SUBJECT: ISSUANCE OF AMENDMENT FOR NINE MILE POINT NUCLEAR STATION, UNIT
NO. 2 (TAC NO. MA0869)

AMENDMENT NO. 84 TO FACILITY OPERATING LICENSE NO. NPF-69 NINE MILE POINT
NUCLEAR POWER STATION UNIT NO. 2

SAFETY EVALUATION BY THE OFFICE OF NUCLEAR REACTOR REGULATION
RELATED TO AMENDMENT NO. 84 TO FACILITY OPERATING LICENSE NO. NPF-69
NIAGARA MOHAWK POWER CORPORATION
NINE MILE POINT NUCLEAR STATION, UNIT NO. 2
DOCKET NO. 50-410

FIGURE 3.4.6.1-1

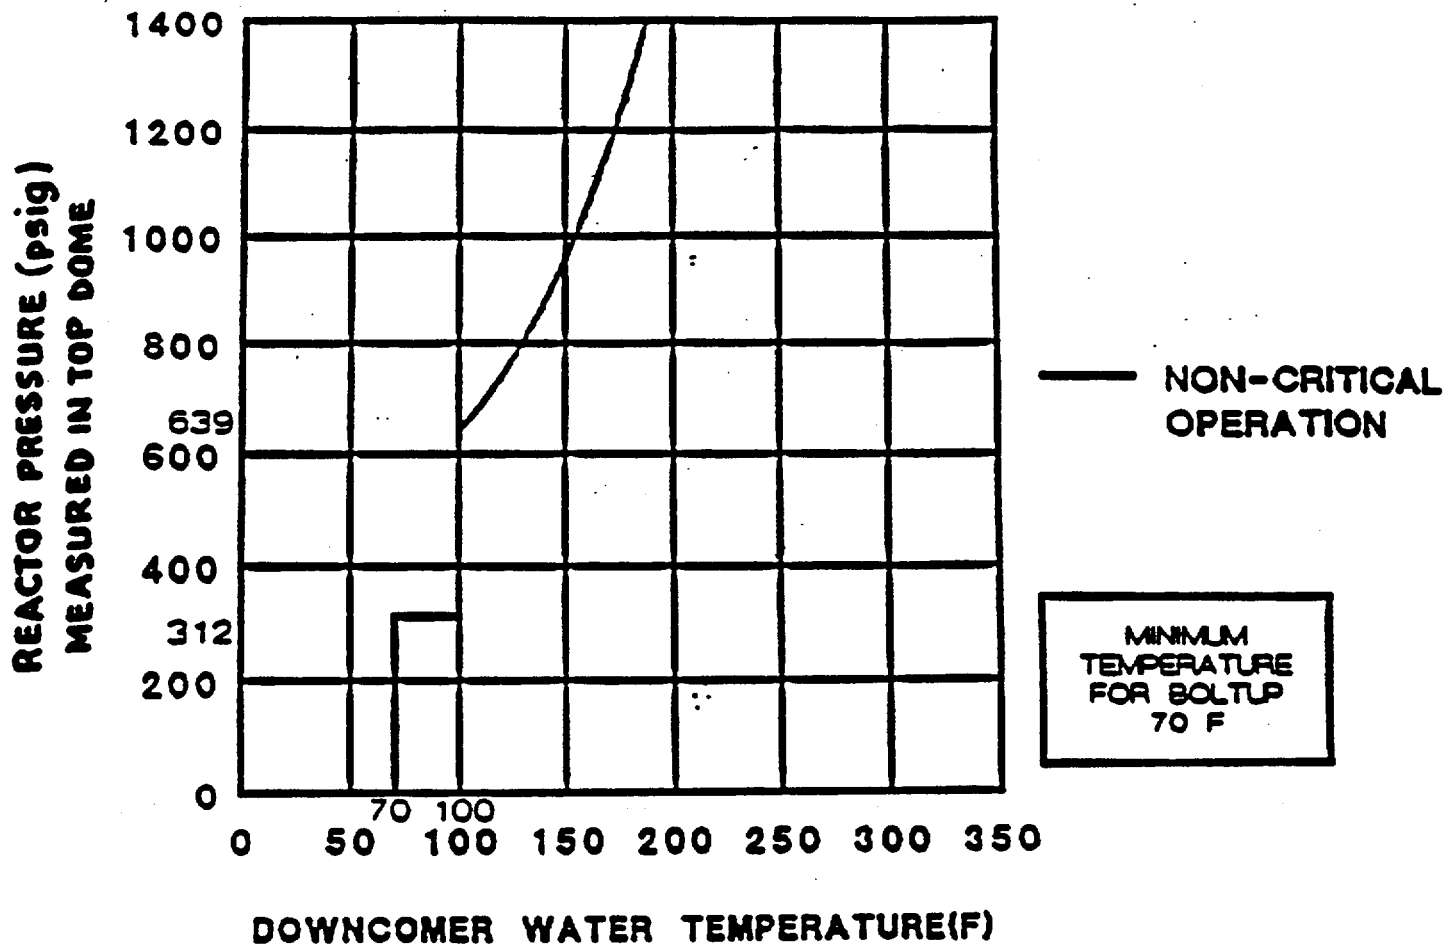
MINIMUM BELTLINE DOWNCOMER WATER TEMPERATURE FOR PRESSURIZATION DURING HYDROSTATIC TESTING AND SYSTEM LEAKAGE TESTING (REACTOR NOT CRITICAL) FOR UP TO 12.8 EFFECTIVE FULL POWER YEARS OF OPERATION

The licensee proposes several changes to terminology to make the references to "hydrostatic testing" and "leak testing" conform with the terminology used in the second 10-year ISI/IST program. The NRC staff finds these changes to be of an editorial nature which does not change the substance of the TS requirement. Similarly, the proposed changes to the TS index are of an editorial nature. These changes are, therefore, acceptable.
